**From:** [Schindler, Jason](#)  
**To:** [Haklar, James](#)  
**Cc:** [Devorak, Coleen](#)  
**Subject:** RE: Hatco revision to Woodbridge Pond remediation approach  
**Date:** Thursday, April 06, 2017 8:45:00 AM  
**Attachments:** [2017-04-06 Woodbridge Pond post-ex grid annotated.pdf](#)

CLIENT NAME: Hatco Corporation  
PROJECT NAME: Woodbridge Pond Remedial Action Outline  
DRAWING TITLE: Woodbridge Pond Pre-Design Confirmatory Sample Location Map  
FIGURE: 4 SCALE: 1 in = 50 ft DATE: 3/13/2017

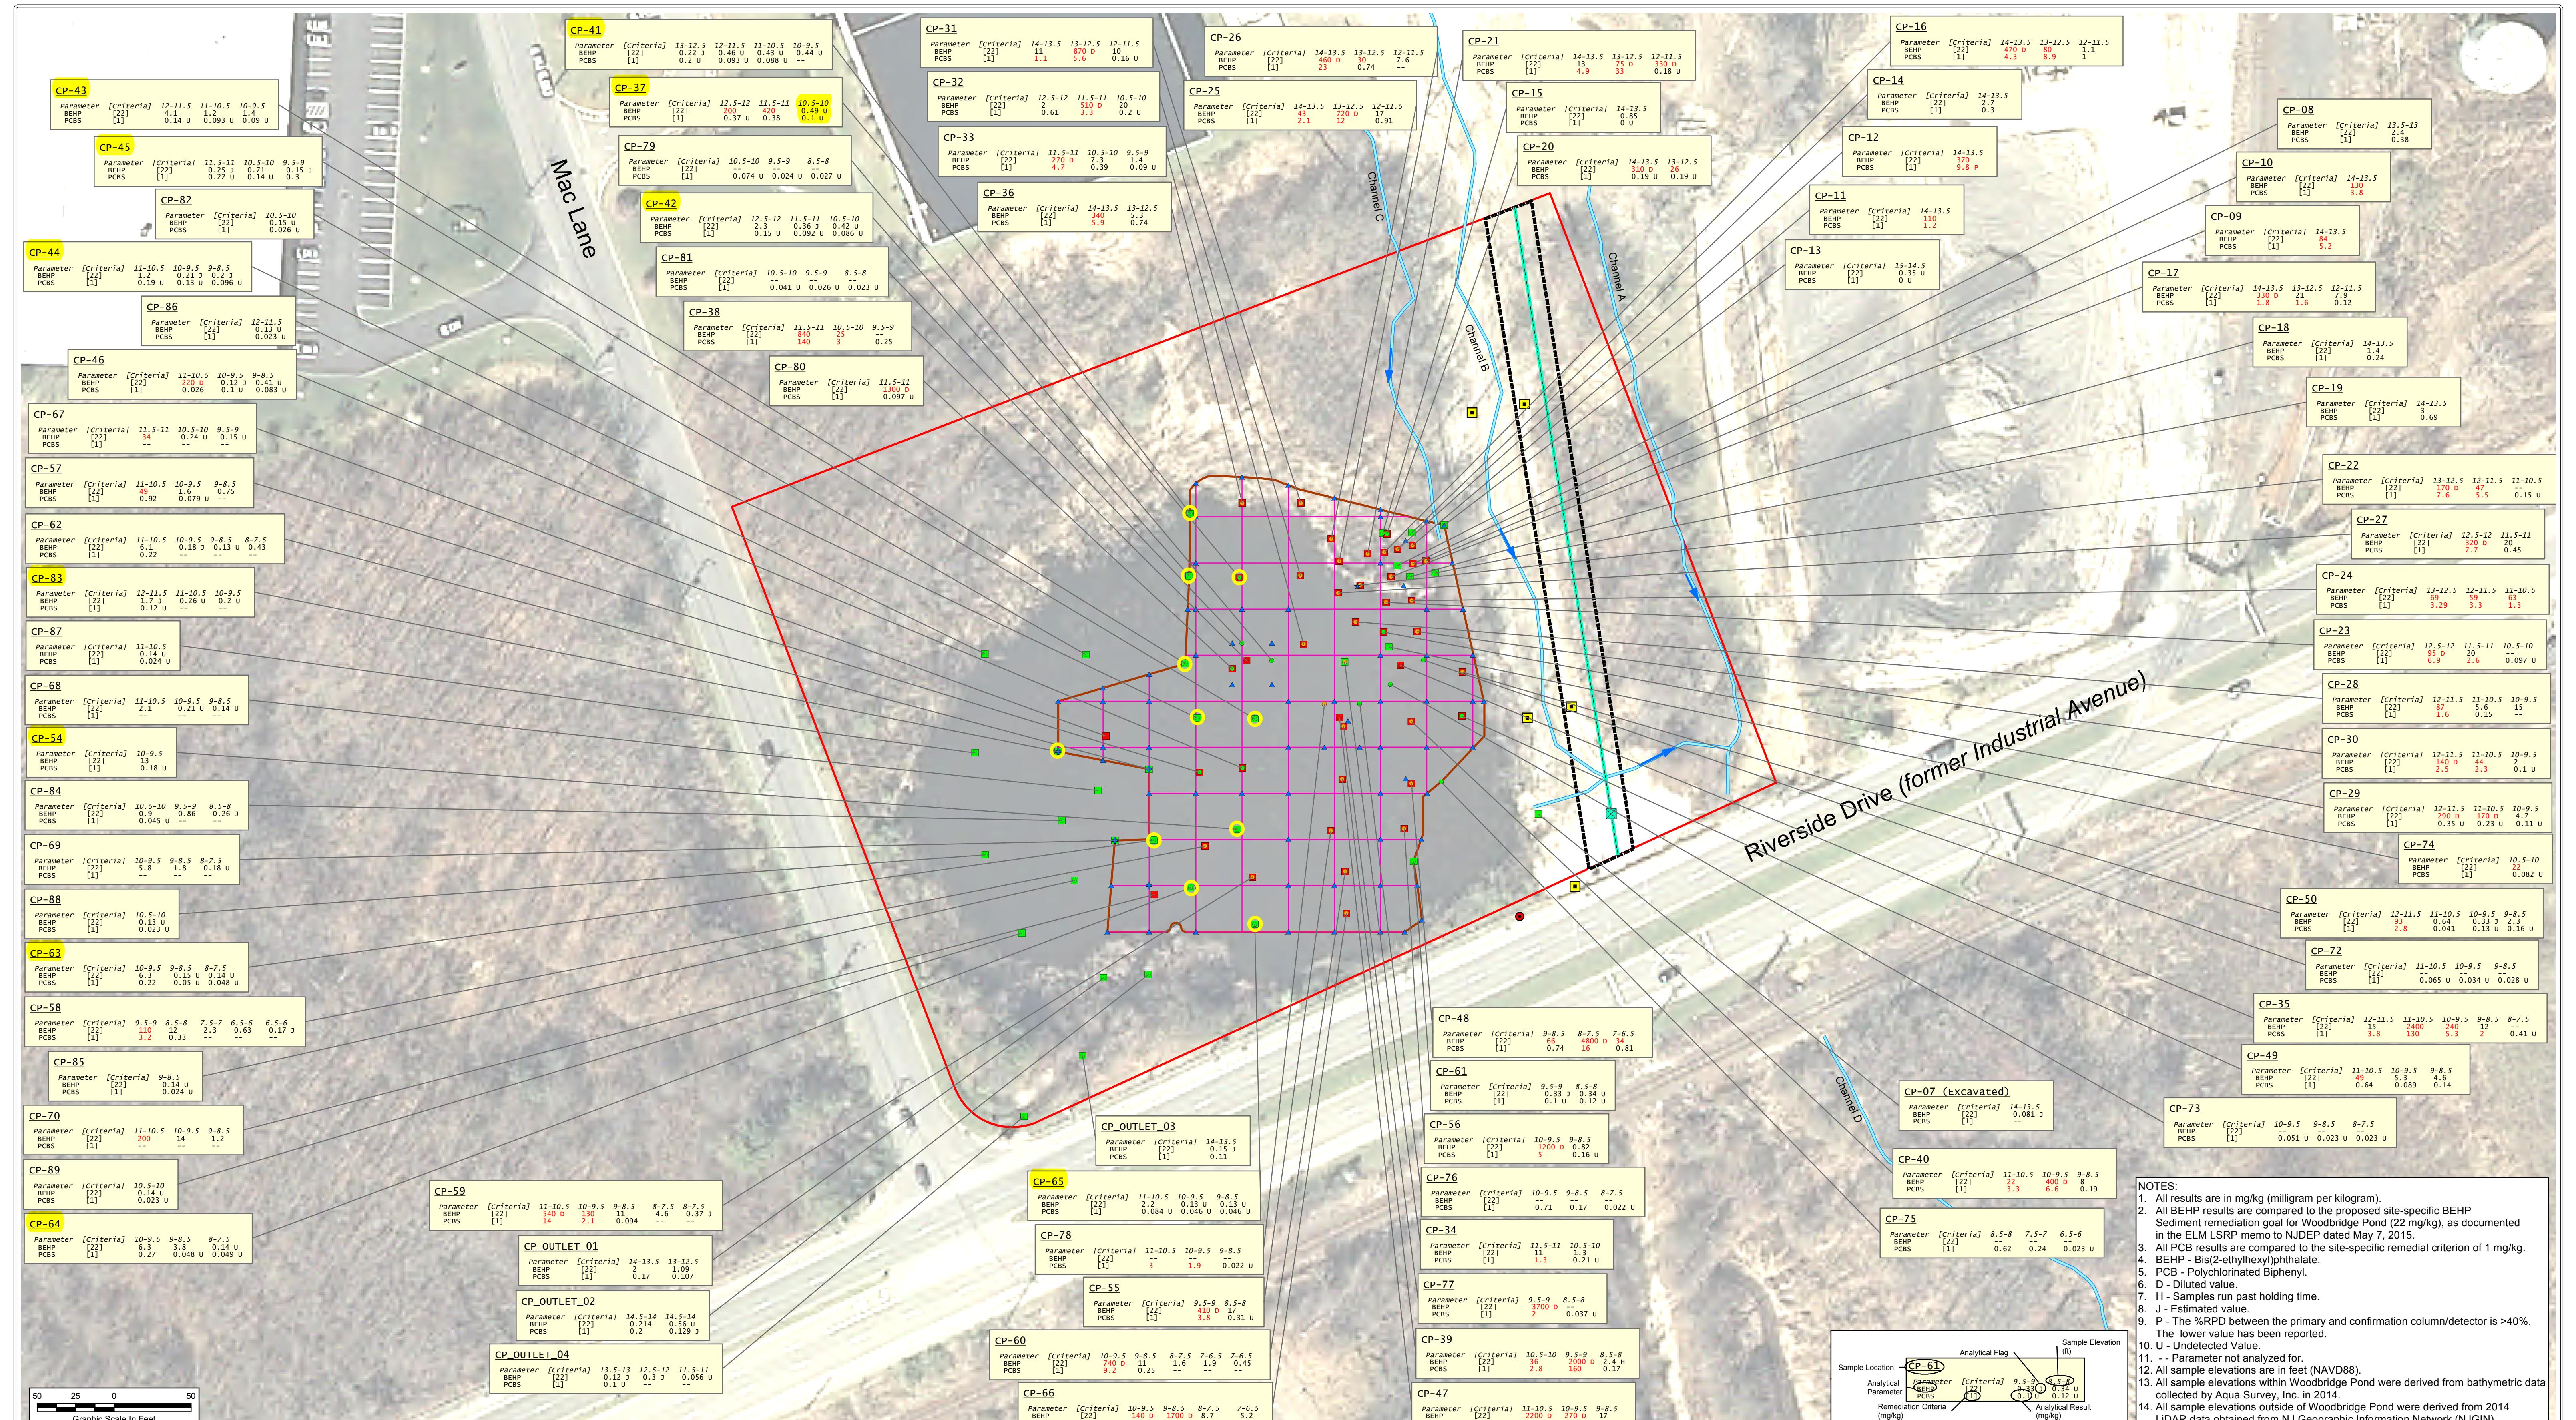
As we discussed here is a copy of the draft figure showing our anticipated limits for dredging and the post-excavation sample grid map. I have highlighted the eleven sample locations with yellow circles. Post-excavation samples will be collected at all of the other grid nodes regardless of whether or not a blue triangle is currently shown on this draft figure.

Weston proposes to rely on existing samples from locations CP-37, CP-44, CP-45, CP-54, and CP-64 to define the bottom at the associated grid nodes

Weston proposes to rely on existing samples from locations CP-41, CP-42, CP-43, CP-63, CP-65 and CP-83 to define the side wall at the associated grid nodes

Weston proposes to rely on existing data to establish the excavation limits at 5 of the 57 bottom sample locations and 6 of the 37 side wall locations. **Why?** This will consist of samples previously collected at locations CP-37, CP-41, CP-42, CP-43, CP-44, CP-45, CP-54, CP-63, CP-64, CP-65 and CP-83. These 11 locations will be dredged to the limits based on the existing data; no post-excavation

**samples will be collected at these 11 locations. Why not?** Data for these locations are summarized on the figure that was included with the Conceptual Plan.

**I'm not sure what this means. Why wouldn't the excavation be extended and additional post-dredging samples collected? Would EPA be involved in the decision-making process?**

Also, this email is intended to clarify the contingency samples. If a contingency sample fails, further evaluation will be performed during this remediation phase and in consultation with USEPA.
